Work Order ID 69355

Item Name: Crosstube Aft

DRAWING NO. D412-664-243	TITLE CROSSTUBE ASSEMBLY (412 HI AFT)	REV. E	DART AEROSPACE LTD ENGINEERING ORDER		D.E.O. NO. D412-664-243-E-1	SHEET NO. SHEET 1 OF 2	SCALE NTS
DRAWN	CHECKED	MFG. APPR.	APPROVED	DE APPR.			
DATE 11.03.31	DATE 11/03.31	DATE 11.03.31	DATE 11/03.31	DATE 11.03.31

**D212-664-243
ASSEMBLY DETAIL**

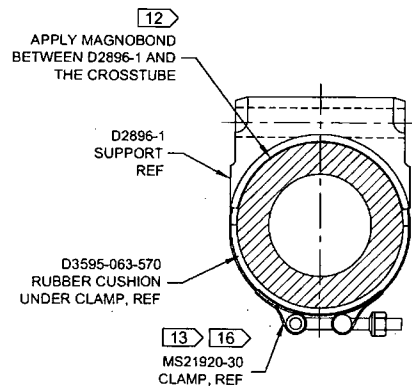
PURPOSE:

REMOVED ABRASION STRIP IN FAVOR OF A THIN LAYER OF PROSEAL 890.

NOTES 2 AND 14, SHEET 1 ARE AMENDED AS FOLLOWS:

- 2) FINISH: CHEMICAL CONVERSION COAT PER DART QSI 005 4.1
PRIME INSIDE AND OUTSIDE PER DART QSI 005 4.2
MASK UNDERSIDE OF CROSSTUBE AS SHOWN (HATCHED AREA)
PAINT OUTSIDE PER DART QSI 005 4.2
AFTER PAINTING, APPLY CLEAR COAT ON HATCHED AREA
- 14) APPLY A THIN COAT OF PROSEAL 890 ON INSIDE CONCAVE SURFACE OF D3189-1
CHAFING SHIELD AND LET CURE PER MANUFACTURER'S INSTRUCTIONS. INSTALL
PROSEALED D3189-1 CHAFING SHIELD ONTO CROSSTUBE BY APPLYING A THIN COAT OF
PROSEAL 890 ONTO CROSSTUBE. BE SURE TO ELIMINATE ANY AIR GAPS.

D3189-1 CHAFING SHIELD (1, INSTALLED OVER PROSEAL 890)
MS21920-28 CLAMP, 2X
2 PL

2
MASK AREA PRIOR TO PAINTING AND
APPLY CLEAR COAT AFTER PAINTING
